STATE OF OHIO
CITY OF CANTON
STA-0153-01.70
MAHONING ROAD NE
ROADWAY IMPROVEMENTS
G.P. 1103

THE PROJECT WORK INVOLVES THE IMPROVEMENT OF APPROXIMATELY 0.67 MILES OF MAHONING ROAD NE, S.R. 153 BETWEEN THE GRACE AVENUE NE AND HARMONT AVENUE NE INTERSECTIONS. THE IMPROVEMENTS INCLUDE NEW STORM SEWERS, CURBS, SIDEWALKS, PLANTERS, SIGNAGE, AND STREET LIGHTING.

REVISIONS	DATE	BY
CONSTRUCTION BIDDING SET	4/21/14	GEA
ADDENDUM NO. 1	5/7/14	GEA

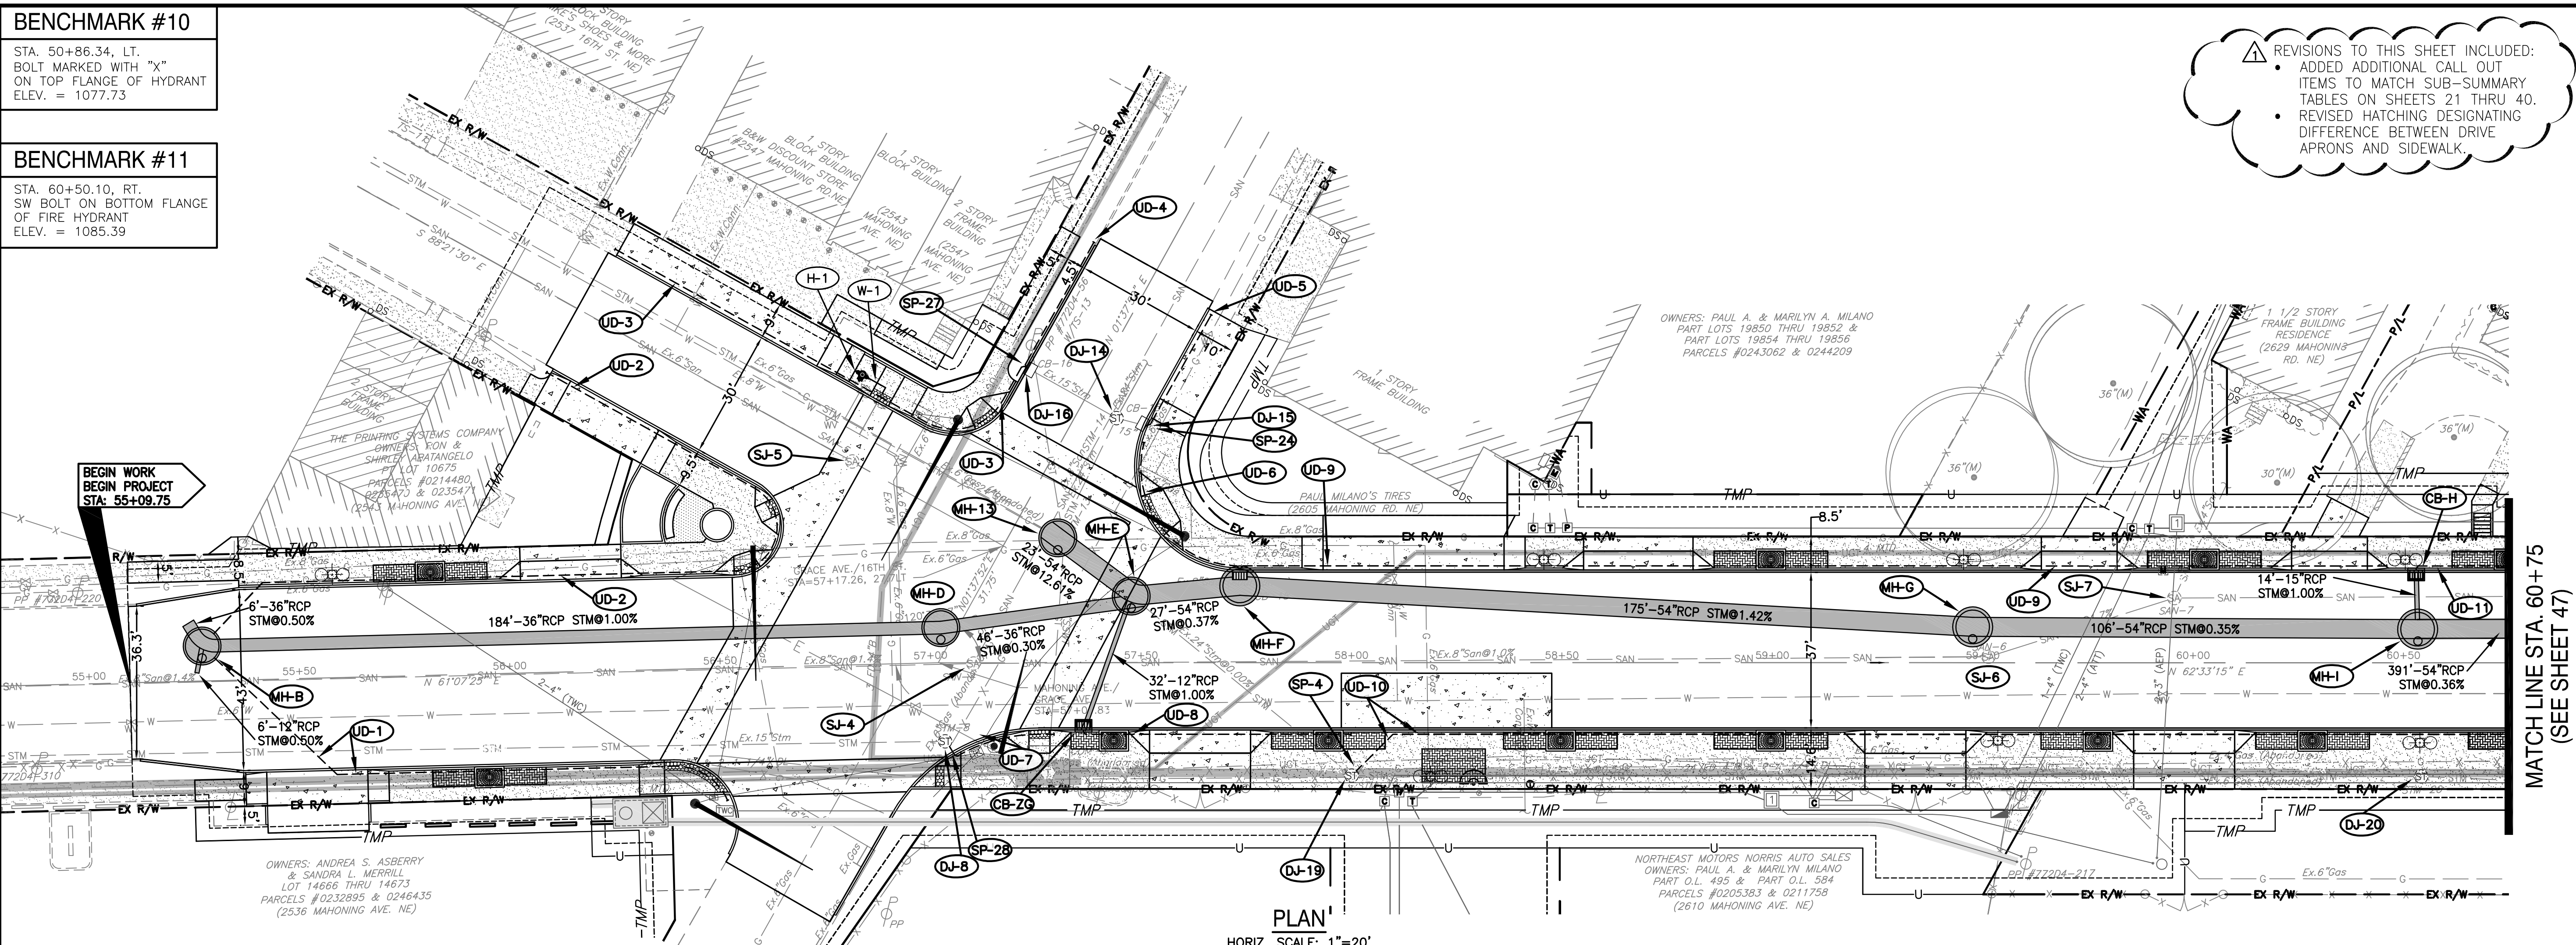
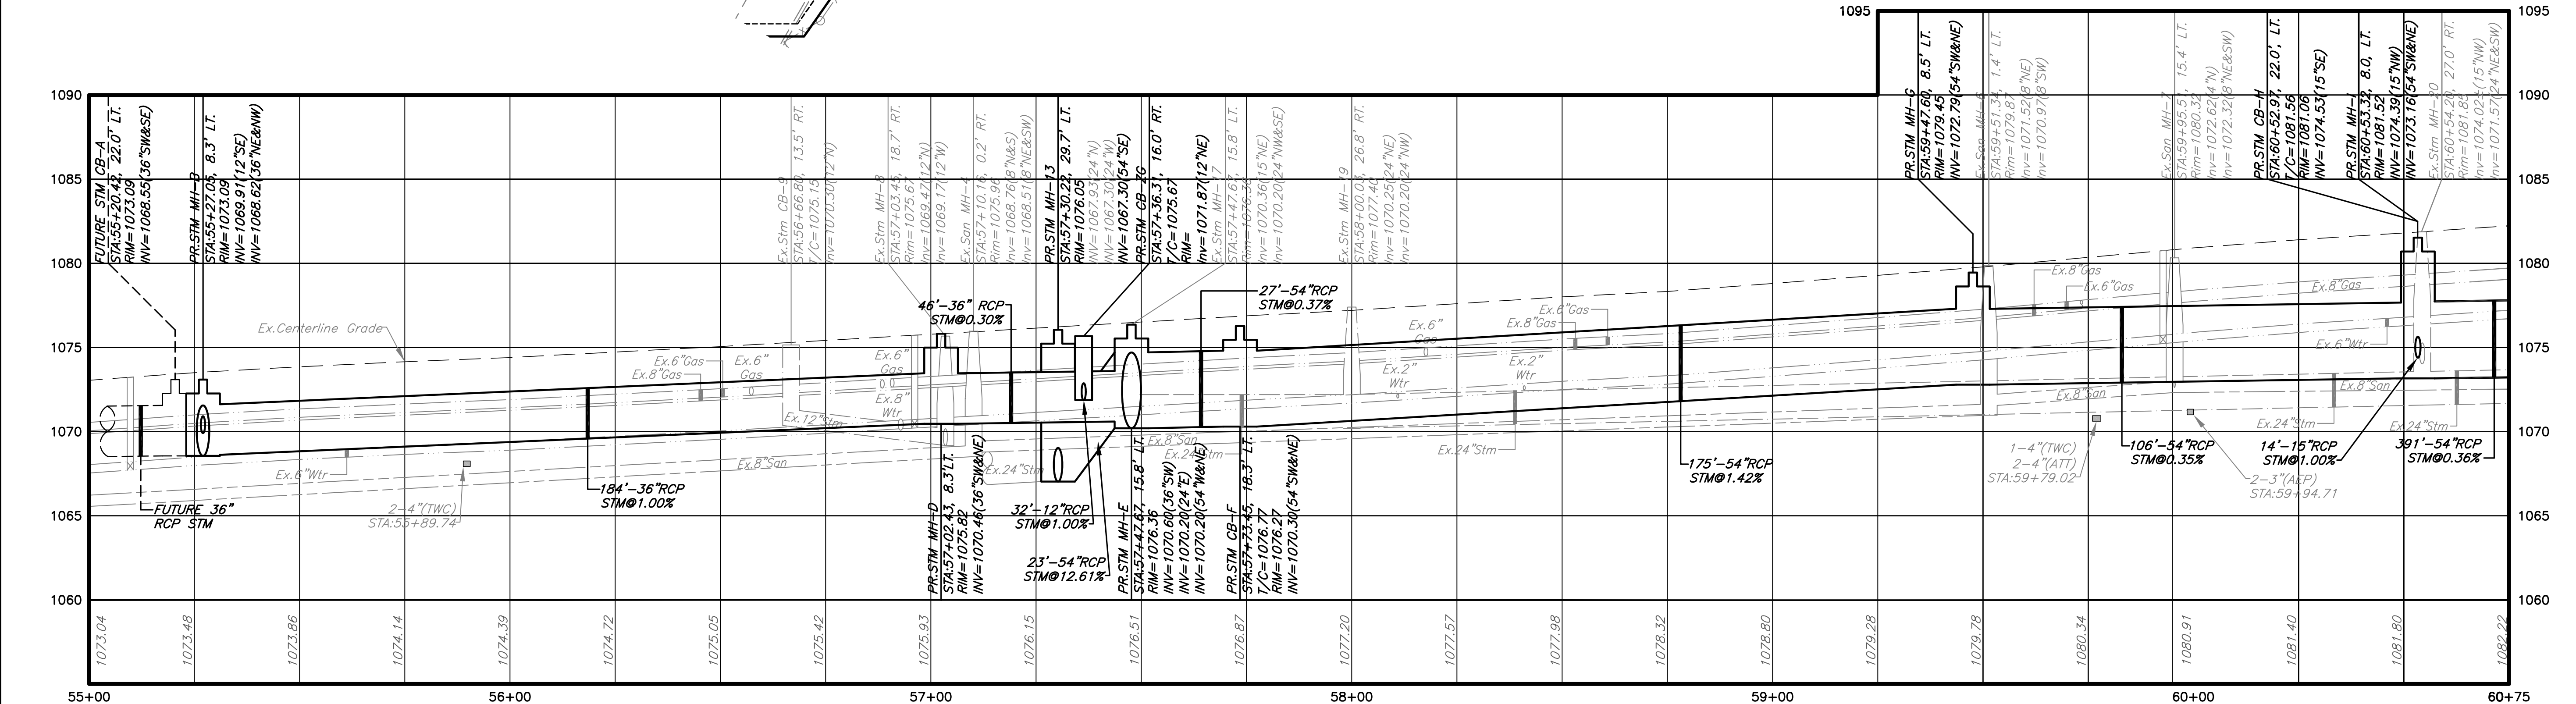
REVISIONS TO THIS SHEET INCLUDED:
 • ADDED ADDITIONAL CALL OUT ITEMS TO MATCH SUB-SUMMARY TABLES ON SHEETS 21 THRU 40.
 • REVISED HATCHING DESIGNATING DIFFERENCE BETWEEN DRIVE APRONS AND SIDEWALK.

PLAN & PROFILE
 STA. 60+75 TO STA. 66+50

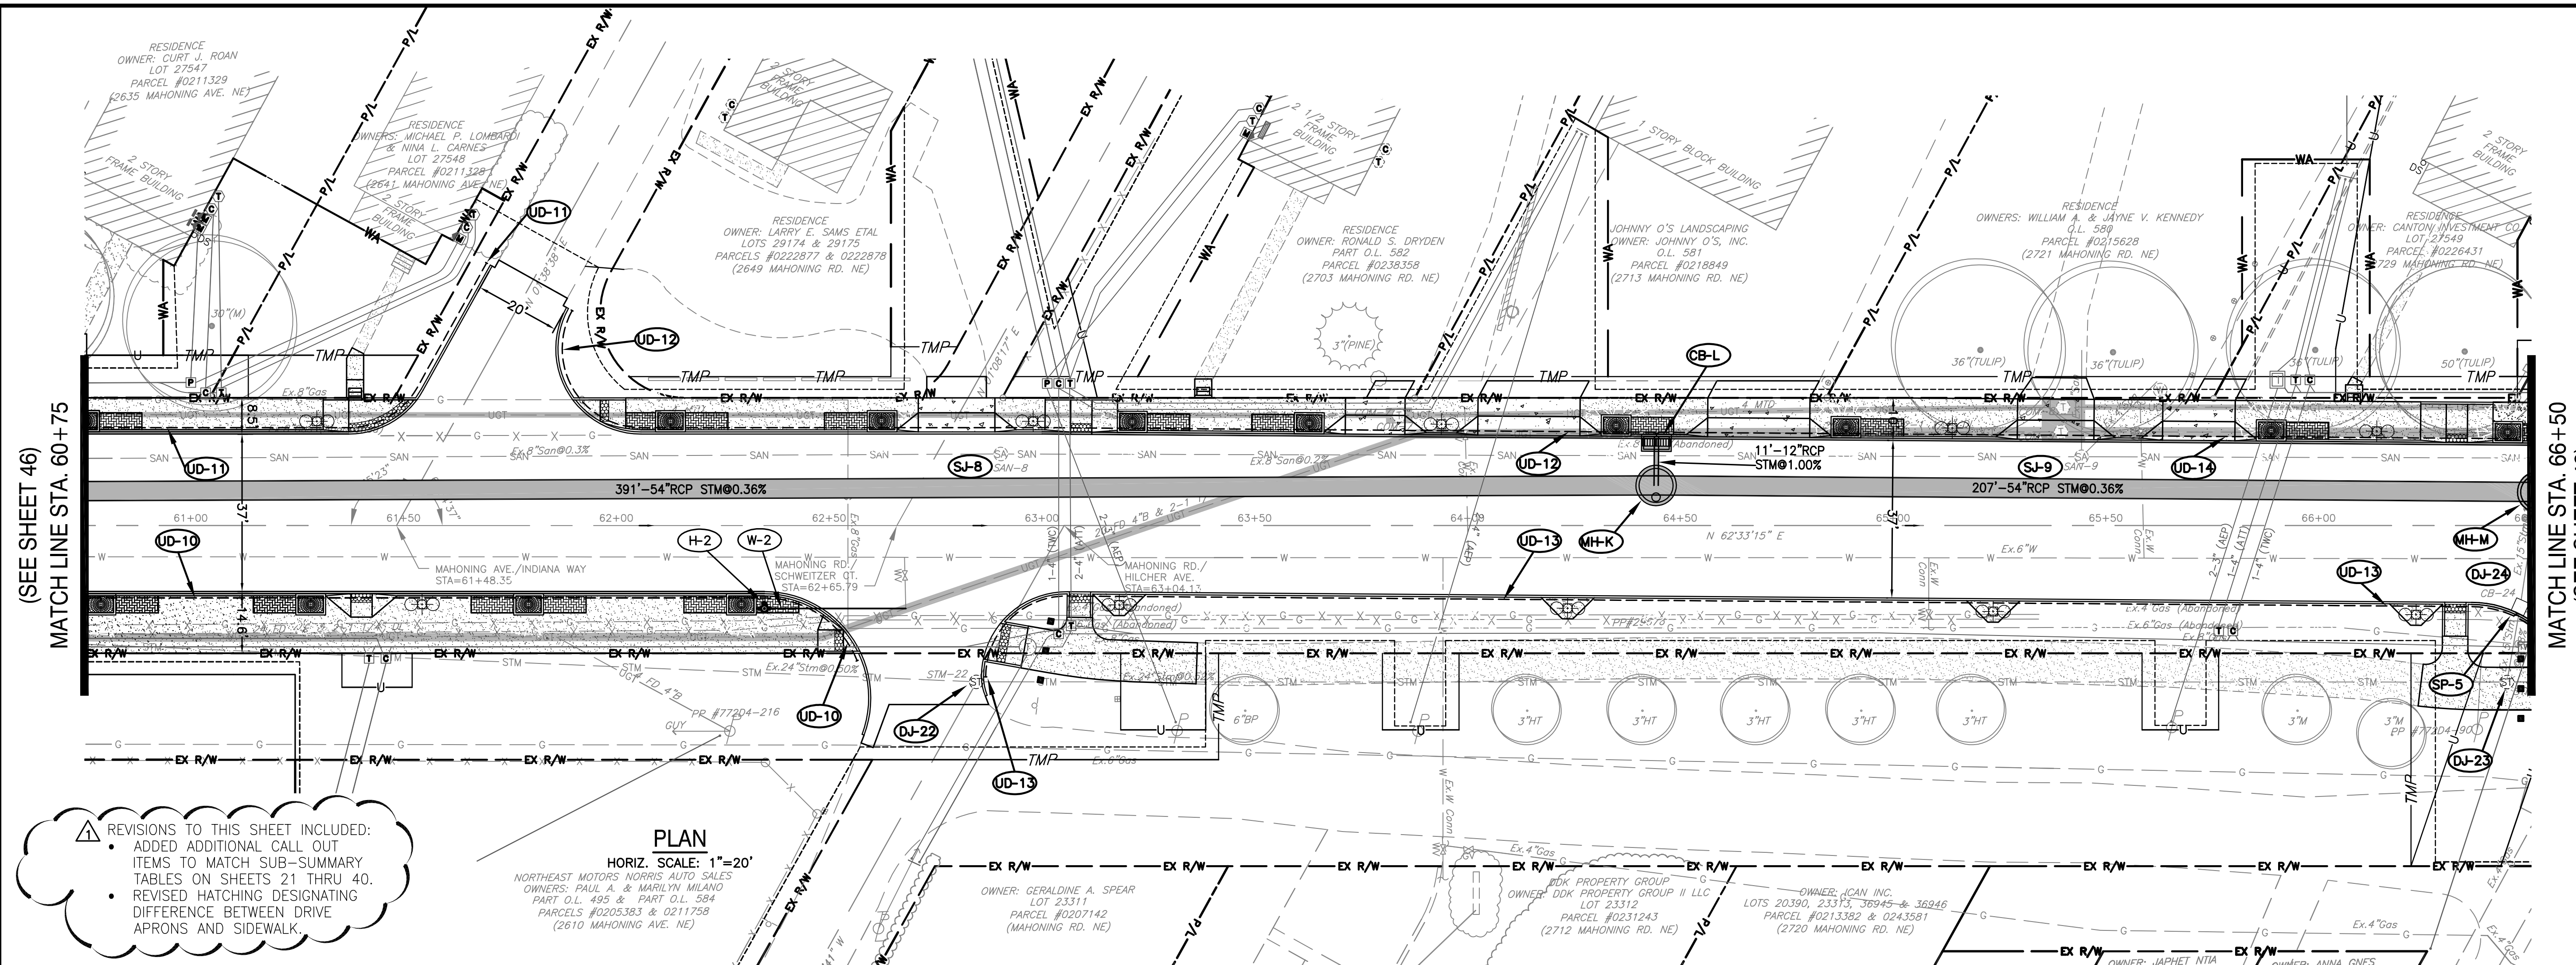
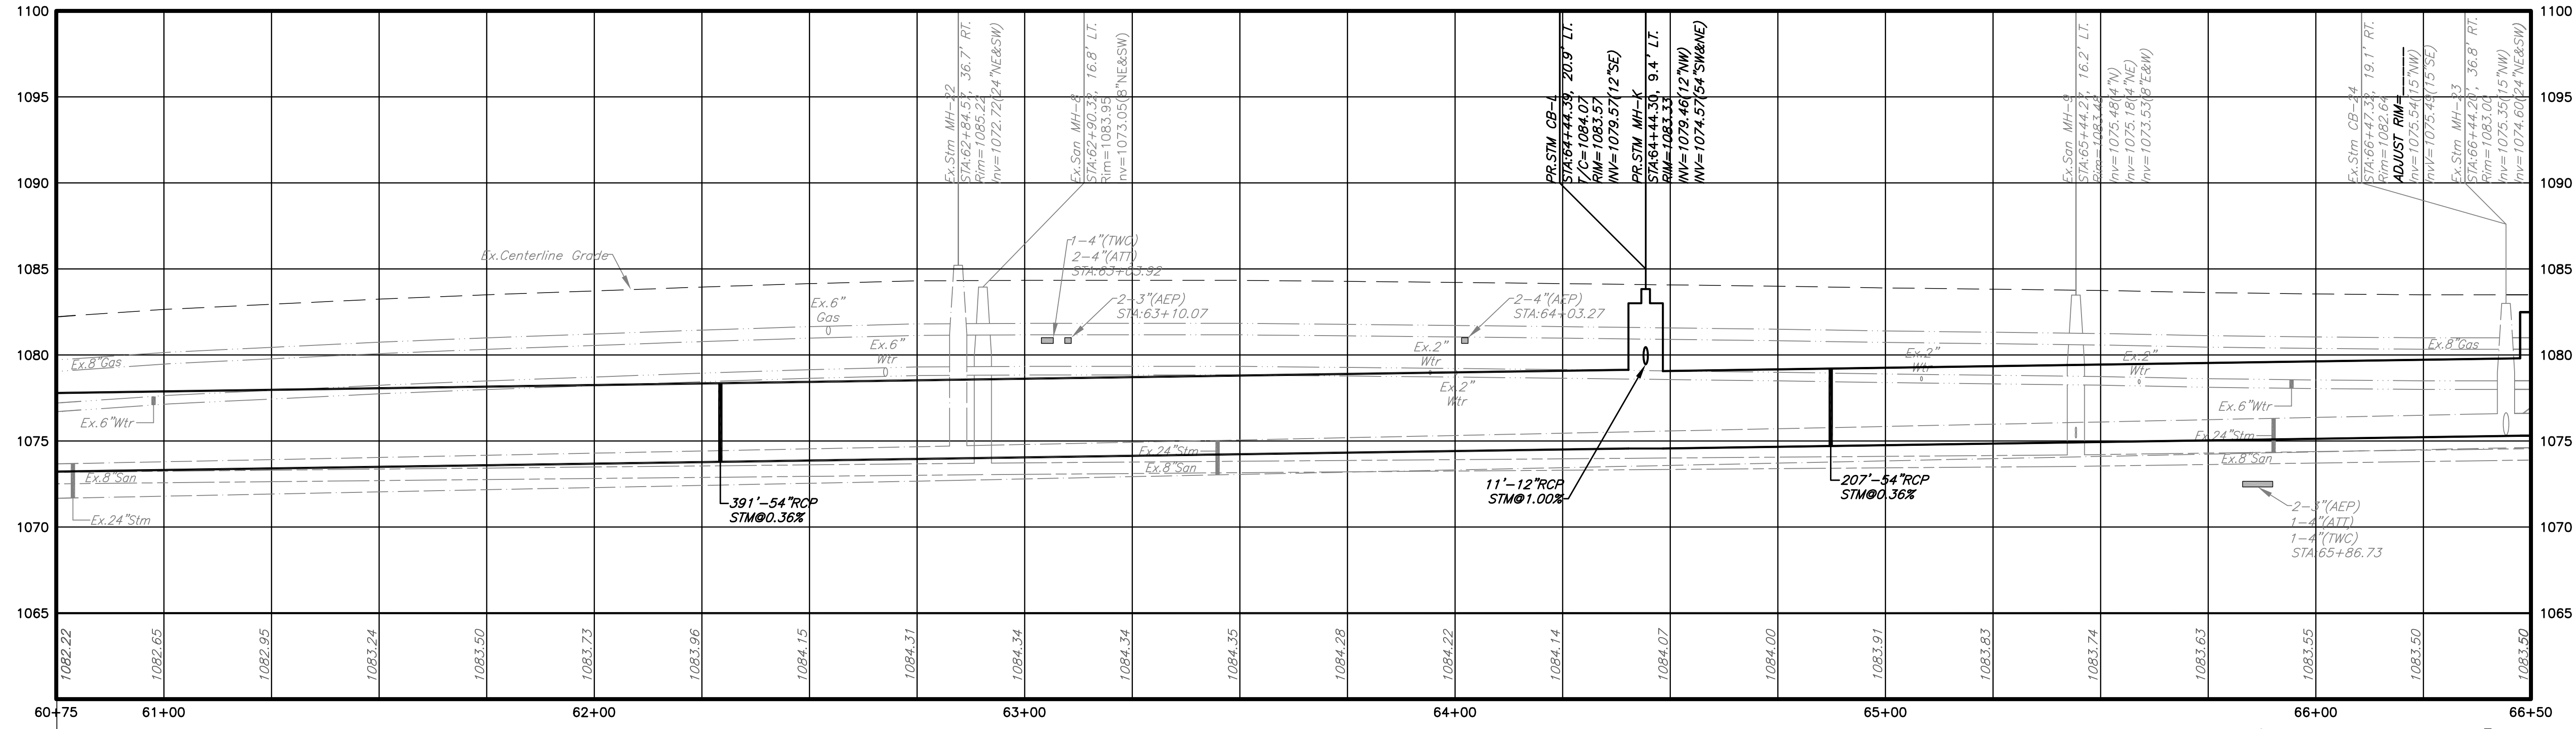
REVISIONS TO THIS SHEET INCLUDED:
 • ADDED ADDITIONAL CALL OUT ITEMS TO MATCH SUB-SUMMARY TABLES ON SHEETS 21 THRU 40.
 • REVISED HATCHING DESIGNATING DIFFERENCE BETWEEN DRIVE APRONS AND SIDEWALK.
